### Haverford Township - Planning Commission

2. Chatham Park Elementary School – Preliminary / Final Land Development Plan 400 Allston Road

RE: Preliminary/Final Land Development Plan Haverford Middle School- 1701 Darby Road

Re: Revised Preliminary / Final Land Development Submission

**PROJECT** SITE **PLAN** 3691

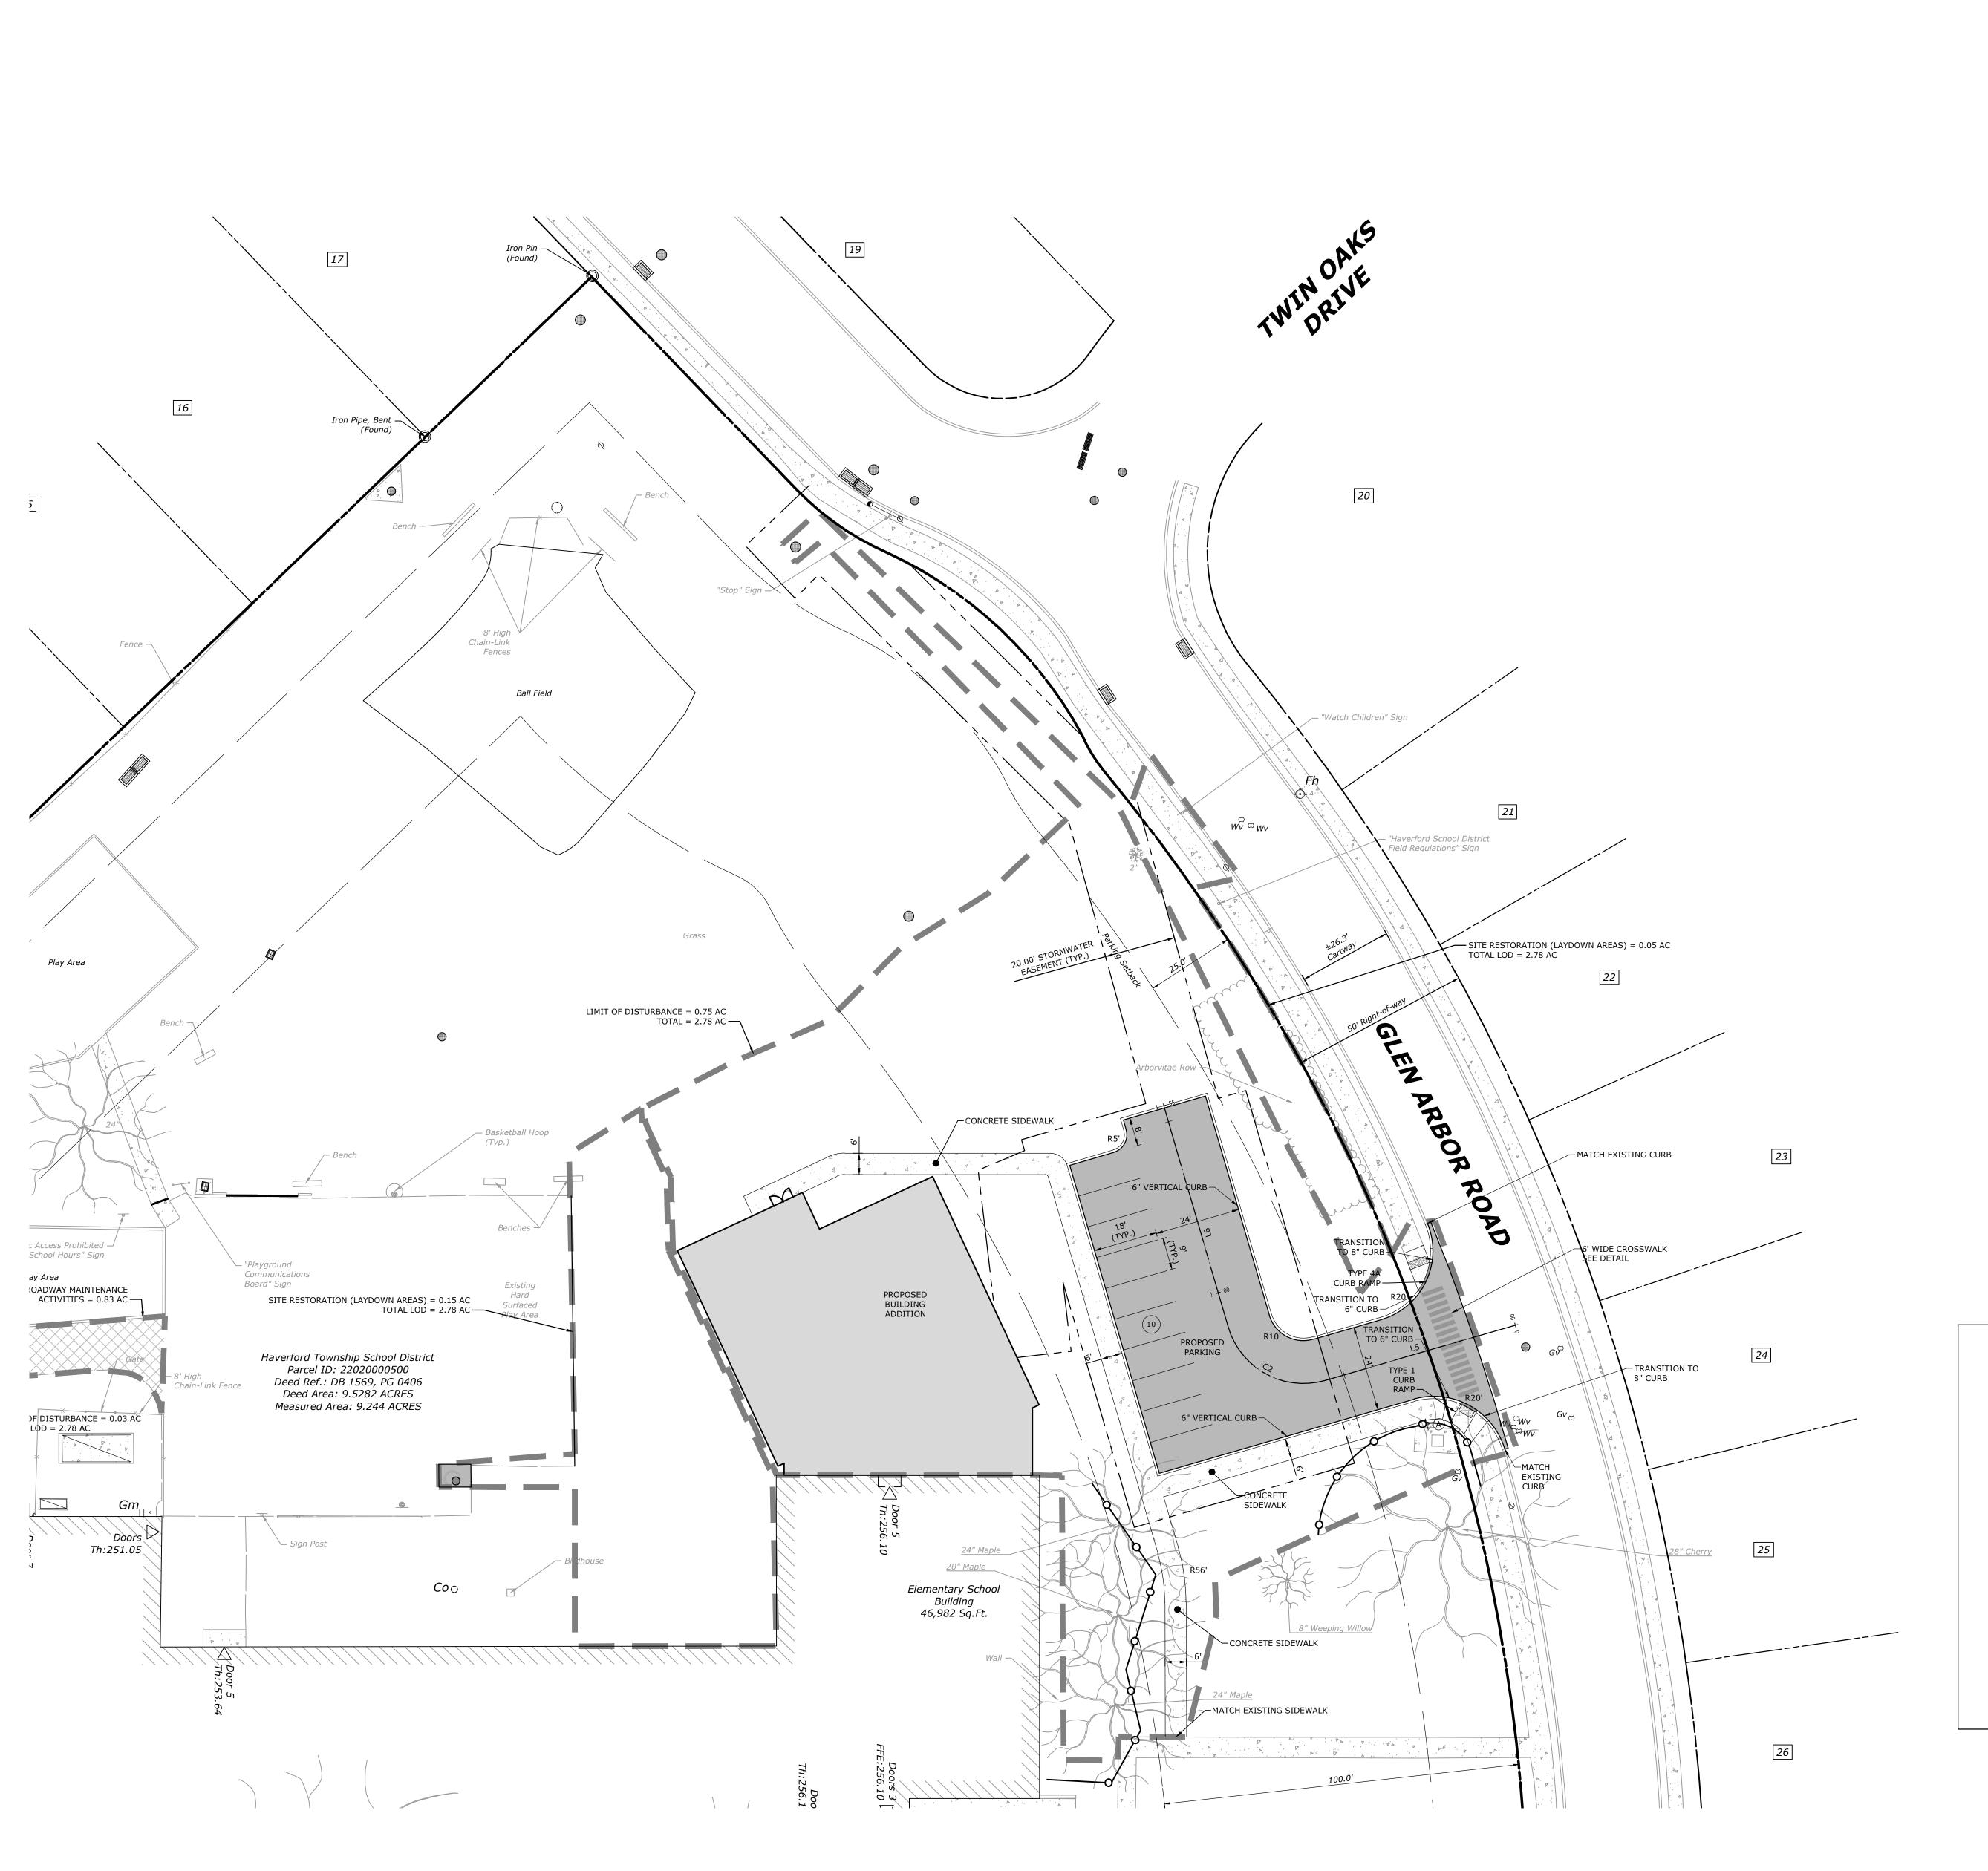
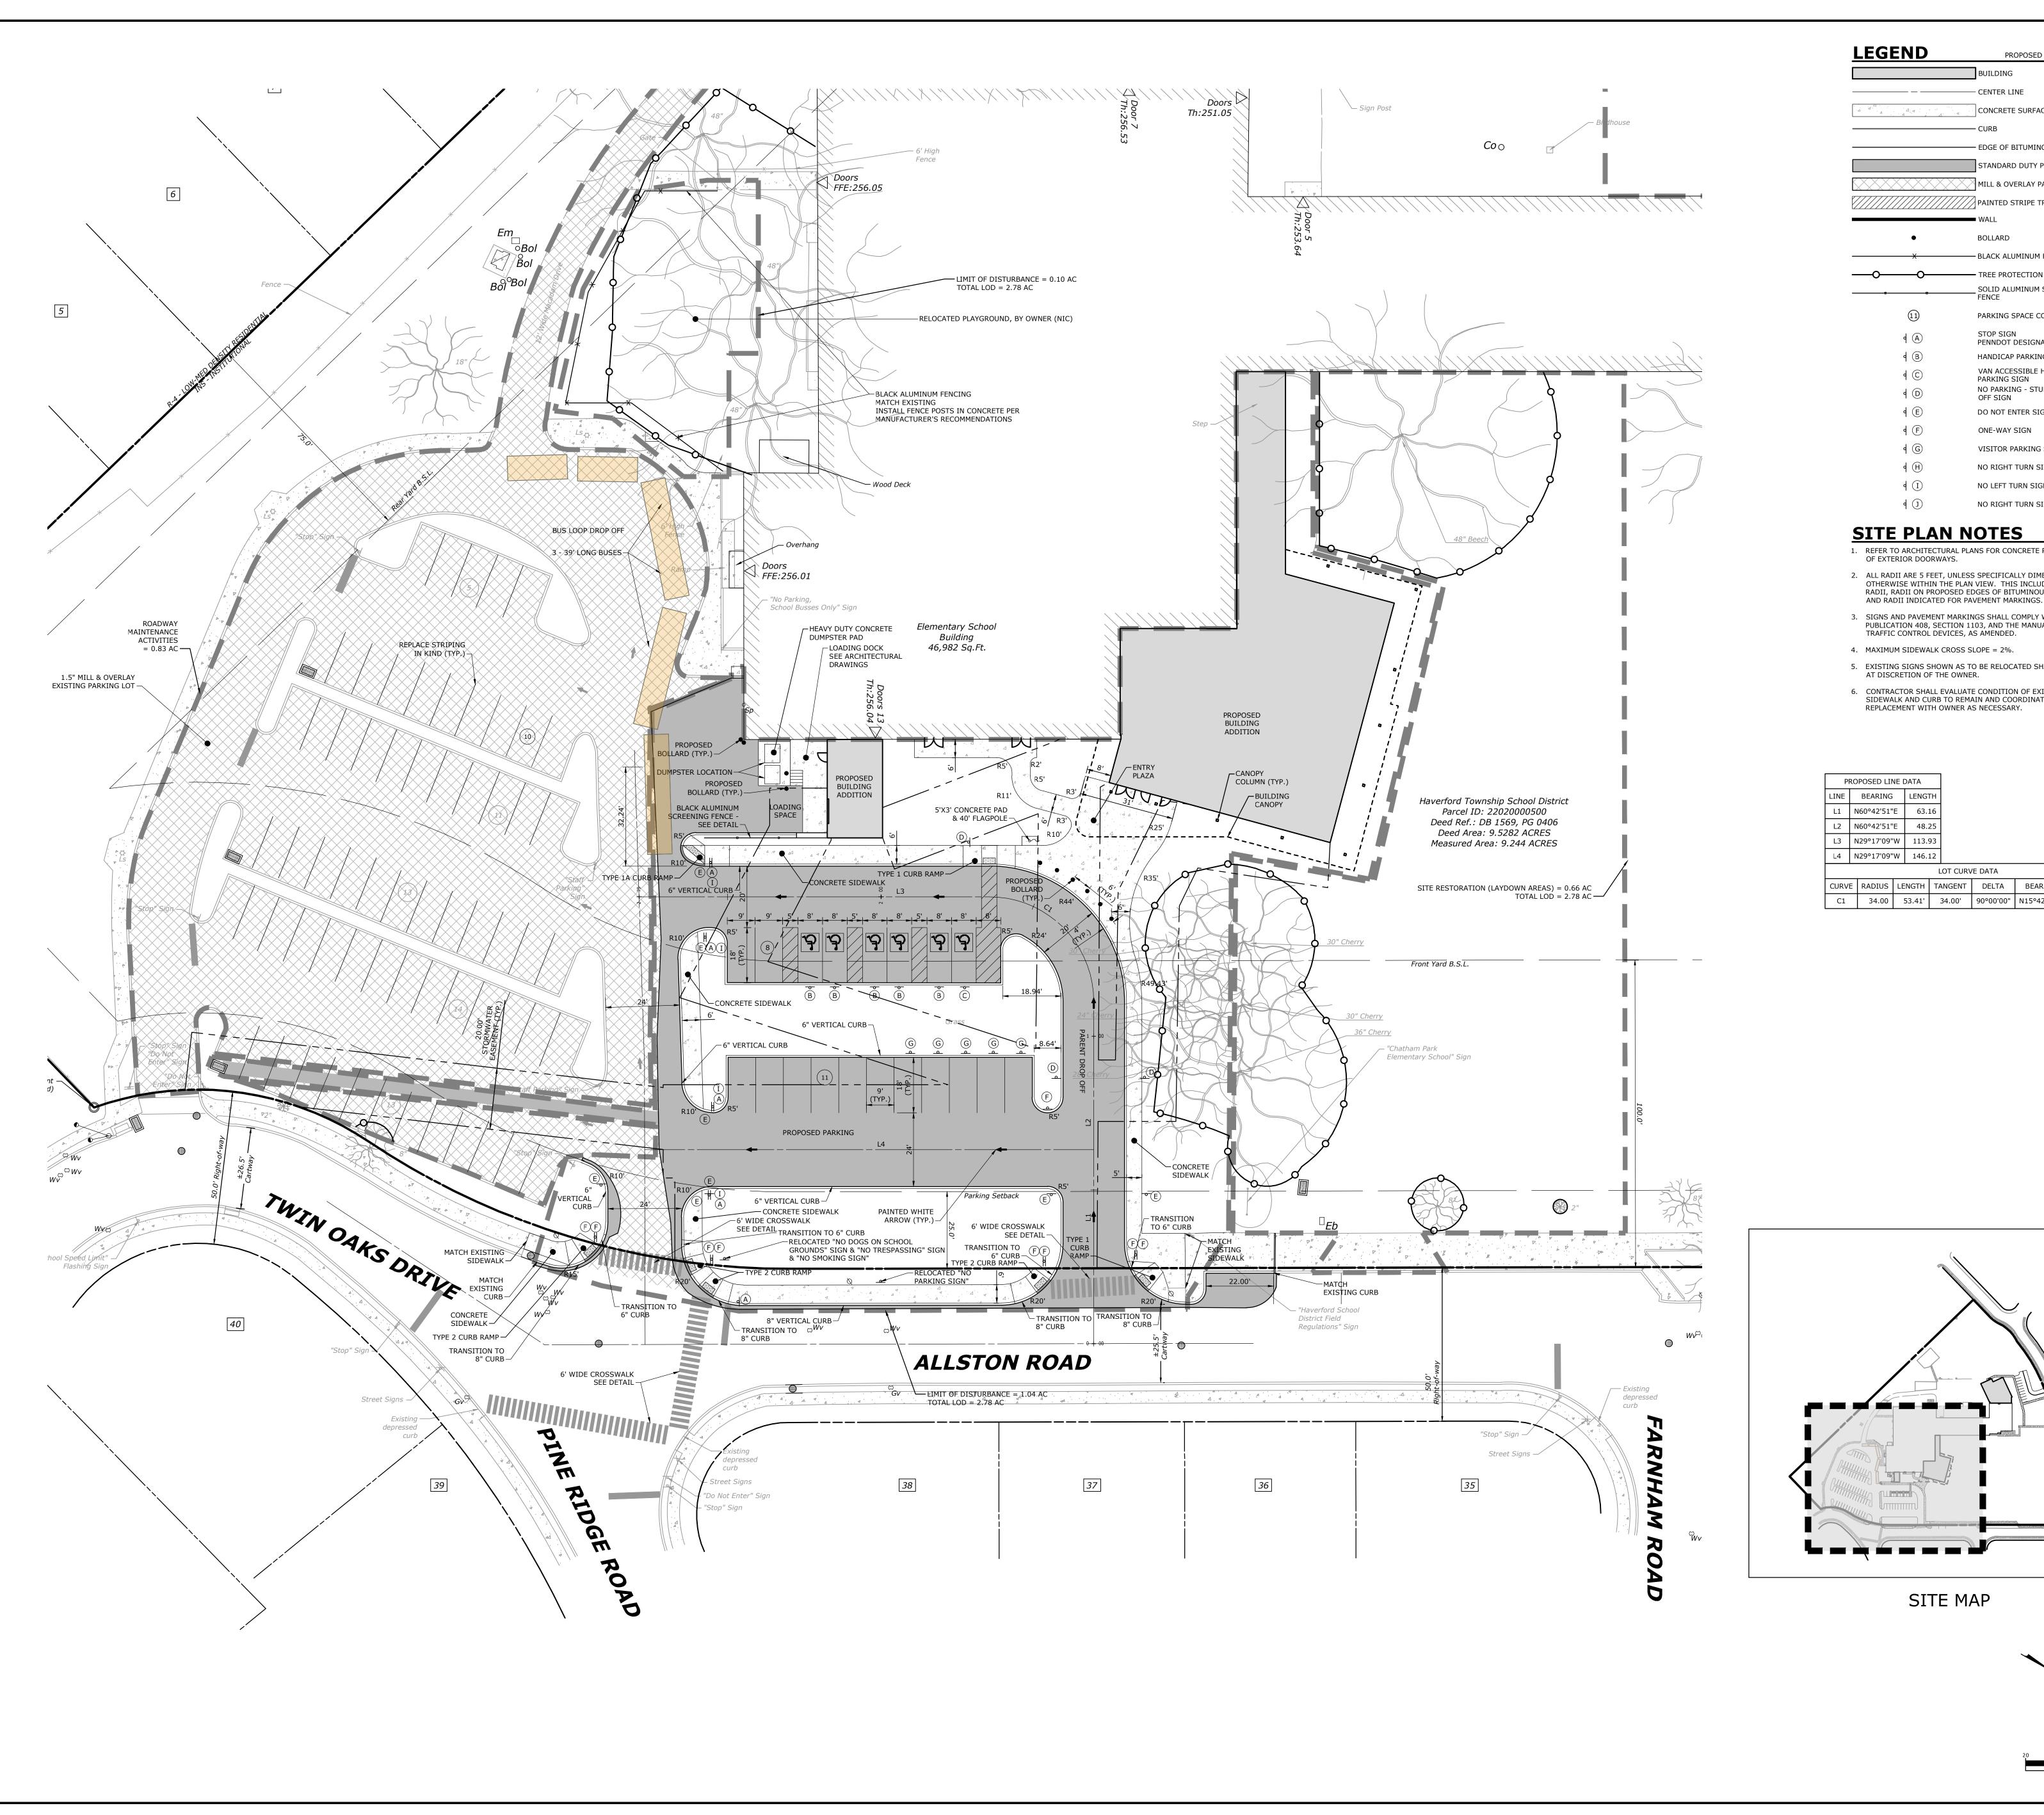
8. Given the additional parking/drop off area and one-way access drive within the proximity of the existing drives and the Twin Oaks Drive/Allston Road intersection, it would be prudent to evaluate the circulation, queuing and pedestrian routes to determine if further improvements/modifications to the area are warranted. The plans should clearly delineate ingress and egress routes for busses and the egress route for cars entering the new parent drop off area. Signage and pavement markings should also be revised to clearly define these routes. Lastly, other alternatives for restricting vehicles from exiting the lot at the middle drive should be explored.

15. It appears the radius associated with the proposed parent drop off driveway will require resetting or relocation of the existing open mouth inlet at the northwest side. The plan should be updated accordingly, and a detail provided.

Response: Additional signage has been added to the site plan per discussions during a meeting on site with Pennoni on Monday, June 17, 2024. See Sheet C-103.1. The northern ADA ramp at the center drive aisle has been revised to be separated into two ramps in order to eliminate the need for turning maneuvers within the street, also per the discussion during the site visit on 06/17/24.

Response: The existing open mouth inlet is now shown to be replaced with a manhole, in order to eliminate the need for any pipe relocations or adjustments within Allston Road. A new open mouth inlet has been shown to be installed just north of the existing, and will connect to this new manhole.
